***Re: Proposed Rezoning for Self-Storage Facility  
600 Albany Post Road, Briarcliff Manor***

Subject: Response to Sarah Yackel's Review Memorandum, dated October 18, 2018, on the Zoning Petition and Full Environmental Assessment Form.

# EXHIBIT “F”

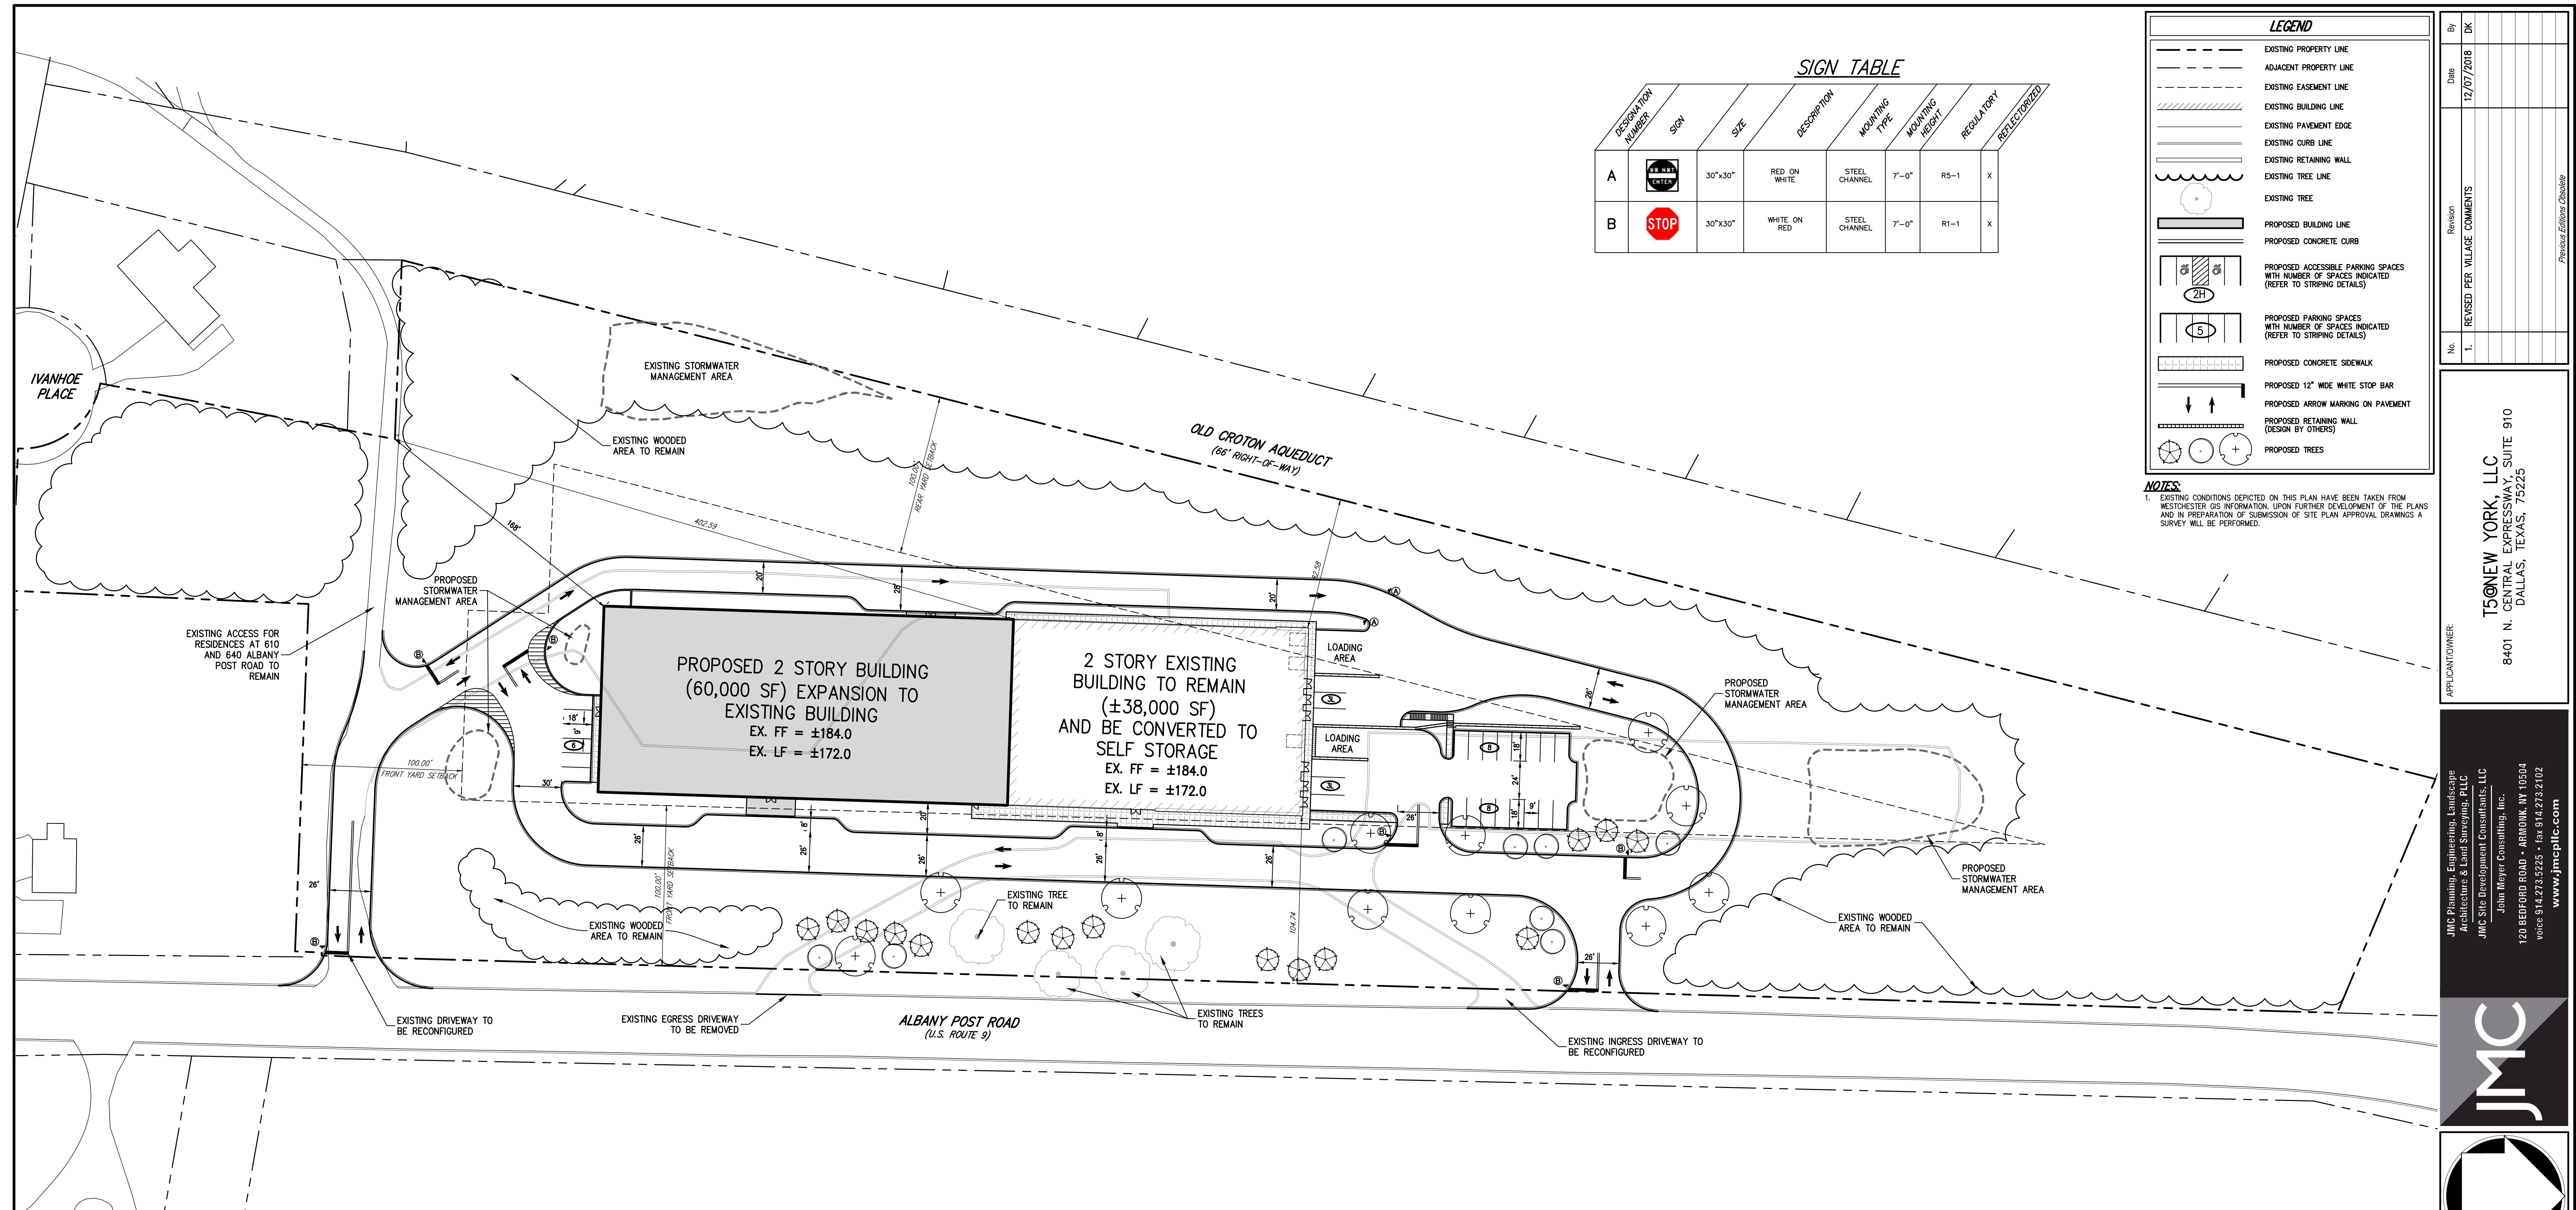
8. Paragraph 24 references the enhancement of the existing landscaping to buffer the surrounding neighborhoods. Additional information should be provided on this.

*Annexed hereto as Exhibit "F" is a revised Conceptual Layout Plan, prepared by JMC, which demonstrates existing landscaped areas, as well as proposed trees to be planted (see legend for symbols demonstrating proposed trees).*
